HISTORIC AND DESIGN REVIEW COMMISSION

June 07, 2017

HDRC CASE NO: 2017-241
ADDRESS: 735 E GUENTHER ST
LEGAL DESCRIPTION: NCB 2882 BLK 7 LOT NE IRR 116.4 OF 8 & NE IRR 113.4 OF 9
ZONING: RM-4, HS
CITY COUNCIL DIST.: 1
DISTRICT: King William Historic District
LANDMARK: Wehrhan House
TYPE OF WORK: Construction of a rear carport
REQUEST:

1 ELEVATION
A1 SC: 1/4" = 1'-0" 9-20-16

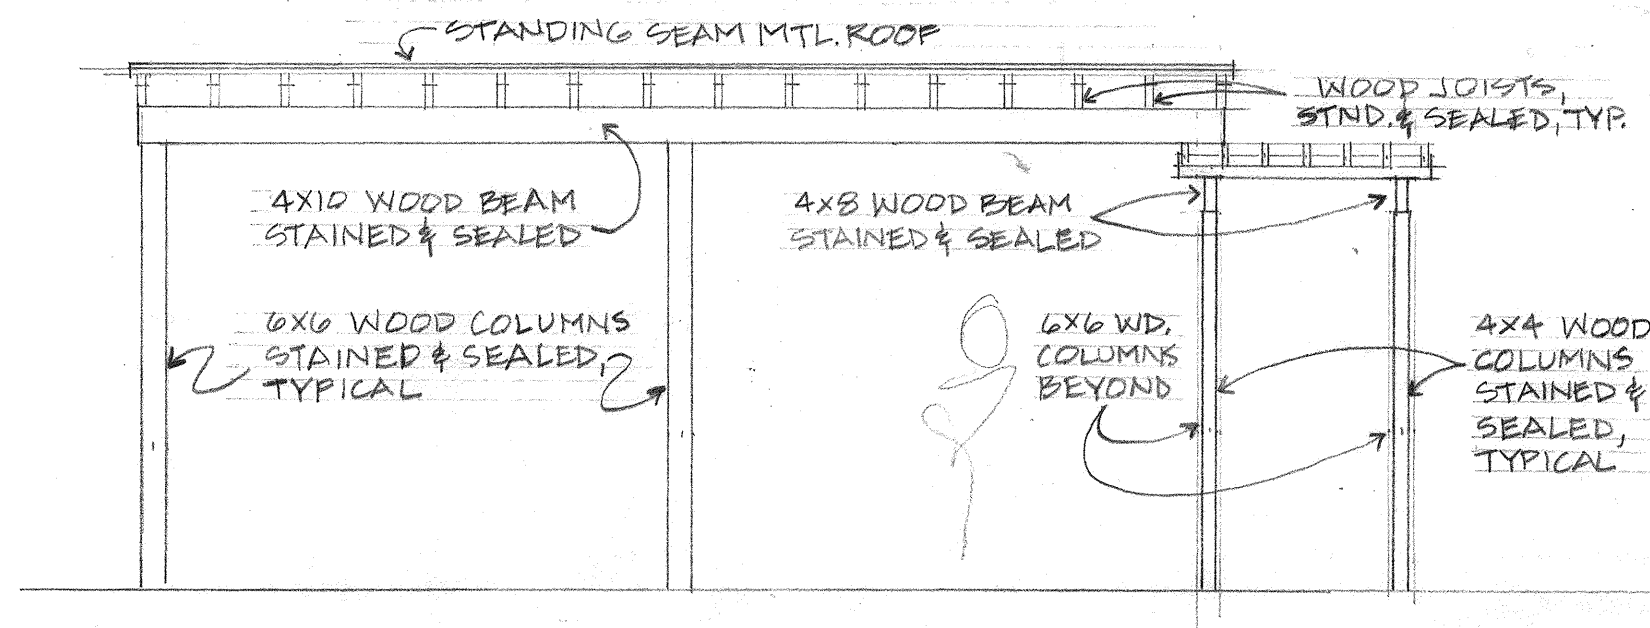
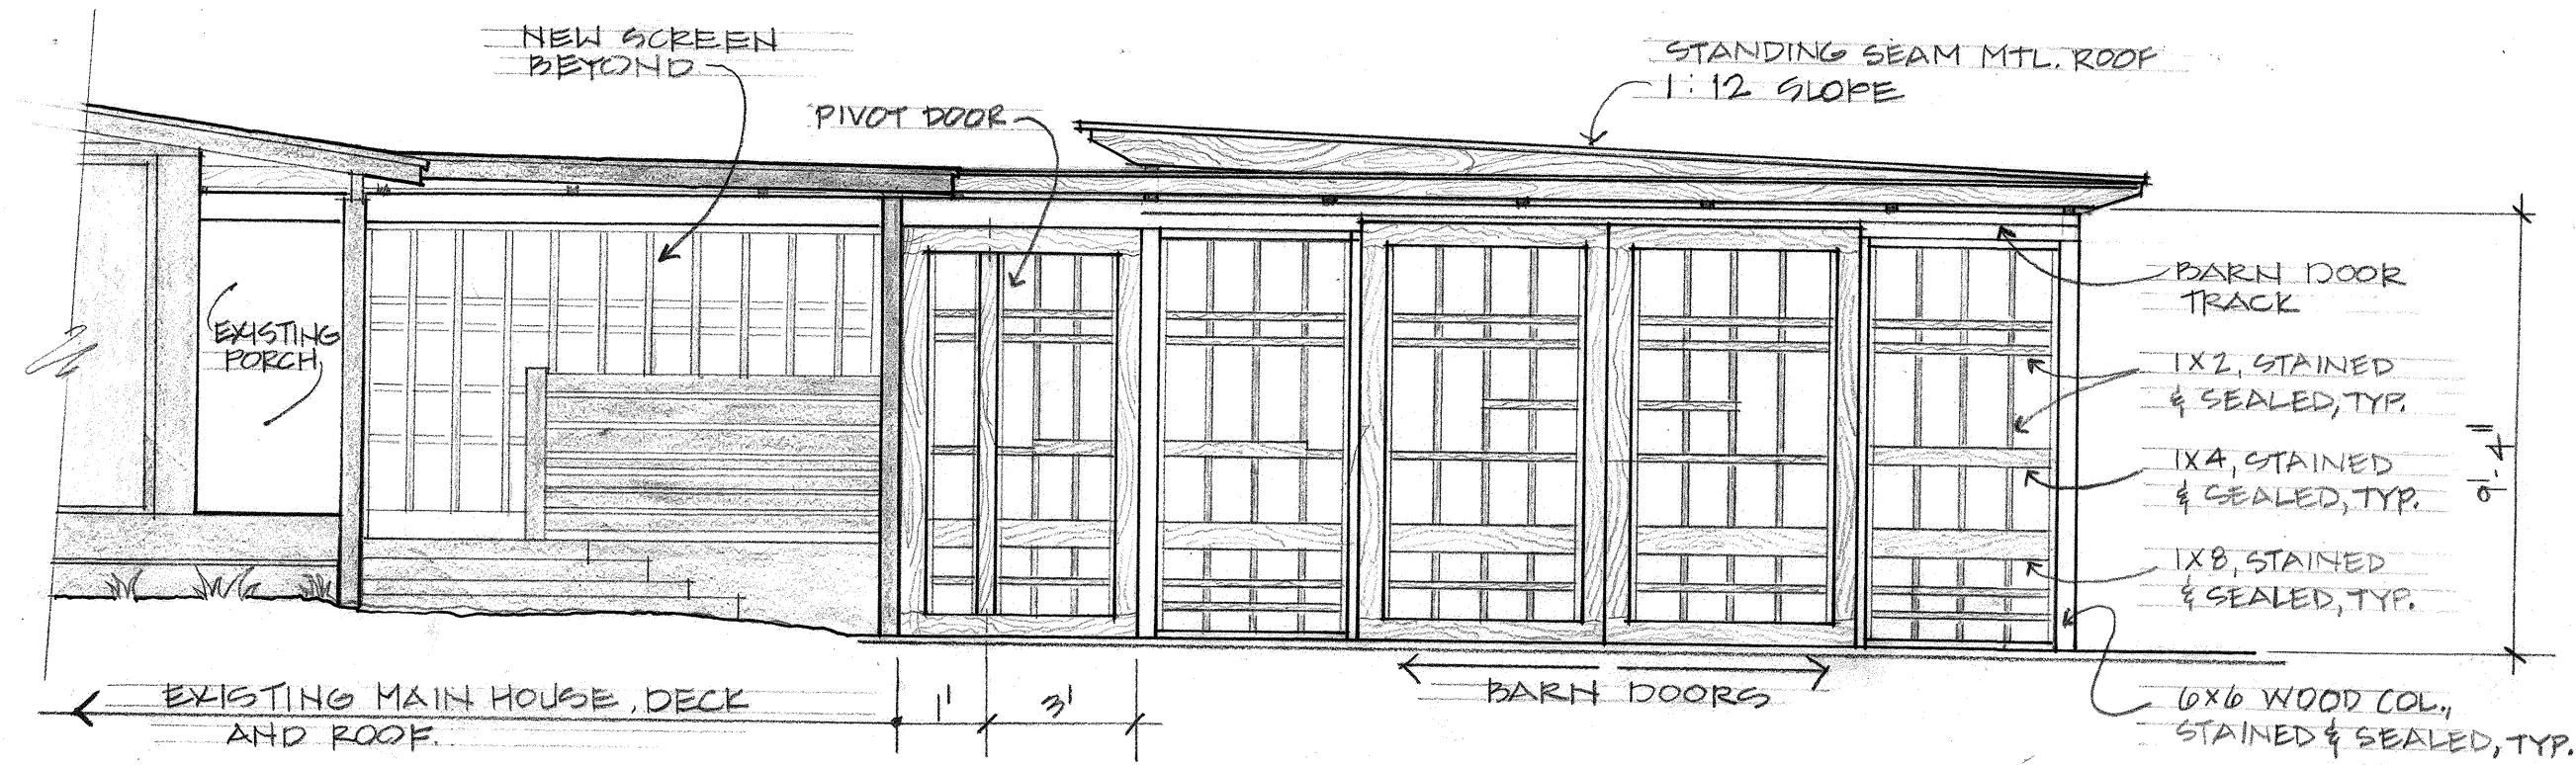
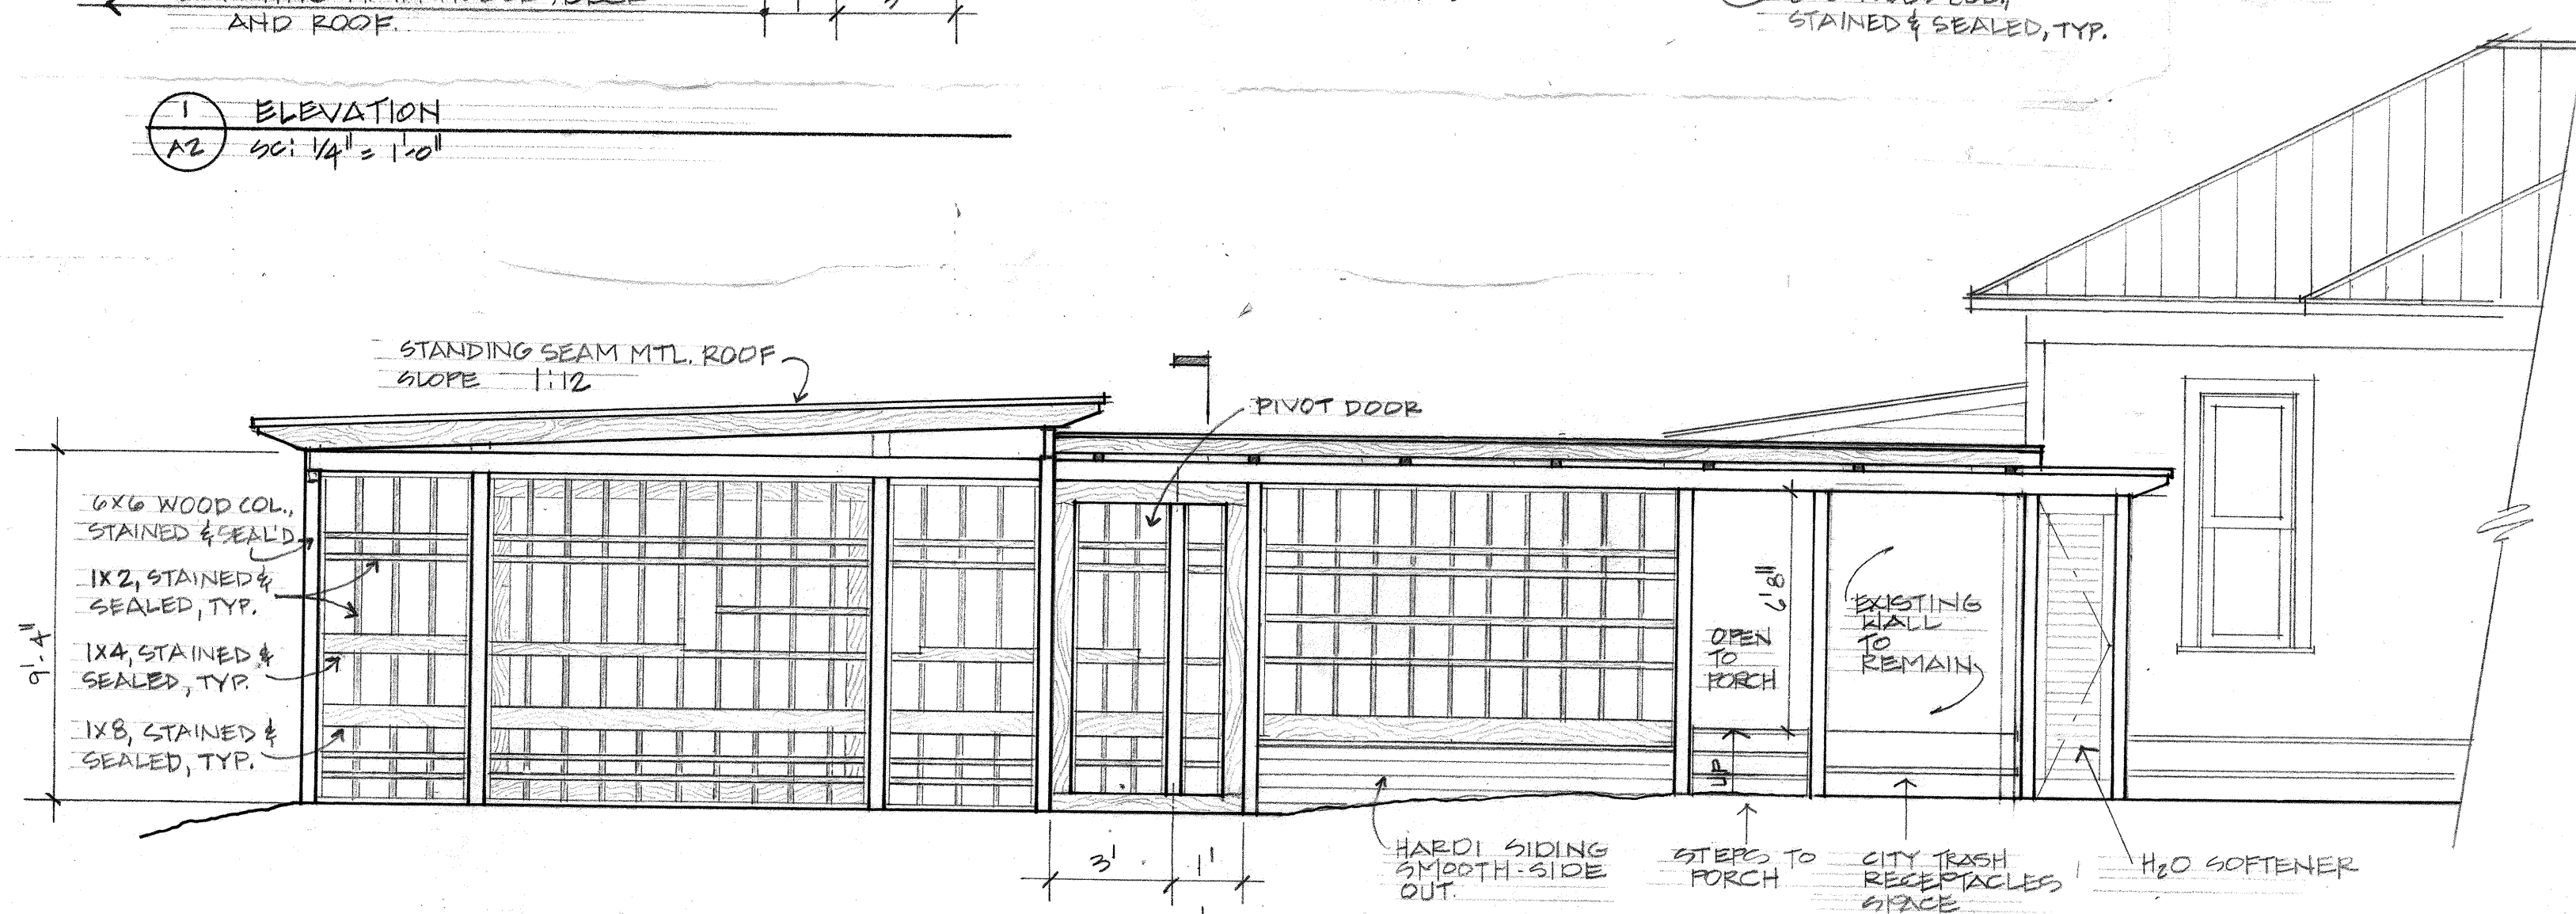
- c. **CHARACTER** – The applicant has proposed materials that include stained wood, sliding doors and a standing seam metal roof. The proposed standing seam metal roof feature panels that are 18 to 21 inches wide, seams are 1 to 2 inches in height, a crimped ridge seam or low profile ridge cap and a standard galvalume finish. Staff finds the proposed materials and detailing will be complementary of the architecture of the primary historic structure and district.

Staff recommends approval based on findings a through d with the stipulation that the standing seam metal roof panels that are 18 to 21 inches wide, seams are 1 to 2 inches in height, a crimped ridge seam or low profile ridge cap and a standard galvalume finish.
